**Re: SOUTH CAMPUS CHILD WELFARE SERVICES SAFETY AND SECURITY
IMPROVEMENT PROJECT, PW 21-28**

ADDENDUM NUMBER 2

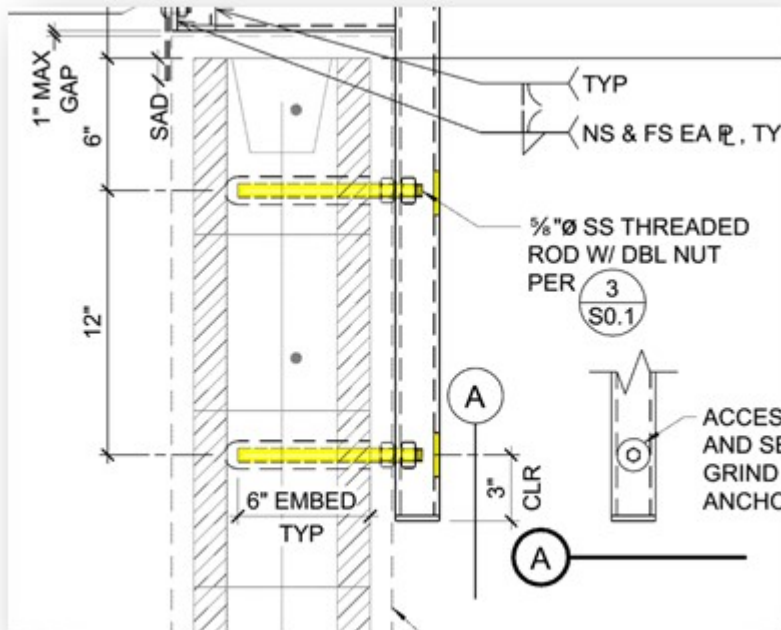
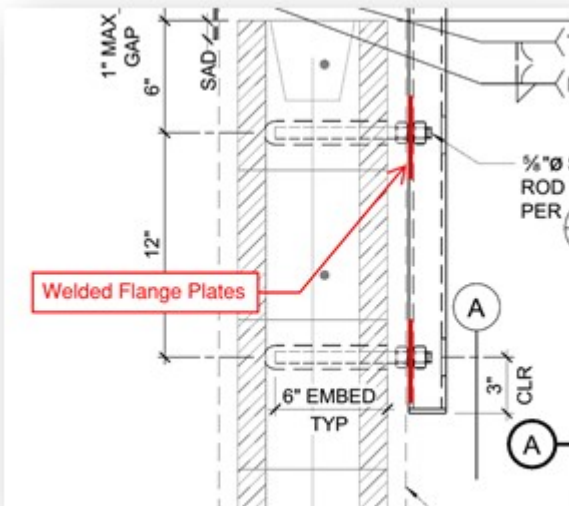
Q1): I'm noticing that the HSS panel mounts are to connect to the wall via a temporary access hole that is to be plugged after installation. There are a number of issues with this approach that I'd like to address before pricing it this way:

- a. Once those holes are plugged, you lose access to the anchors. If, for whatever reason, an anchor were to come loose, you would have to deconstruct the entire panel mount in order to rectify the issue.*
- b. Whatever plugging and grinding we would have to do to the area would completely ruin the finish on the steel. Even after touch-up, the difference in finish would be notably obvious.*
- c. This mounting application would be much more expensive than a standard welded flange plate approach.*
- d. We'd like to suggest welding flange plates to the "wall side" of the mounts allowing for exterior anchor access (this is a standard mounting technique for similar applications) similar to the aluminum panel to steel mount flange plates shown on the detail.*

Per Plans ↓

Suggested ↓

A1): The bolt access holes in the HSS shall remain open for future access. Grind the edges of opening smooth prior to powder coat finishing in the shop. See updated detail for more information.
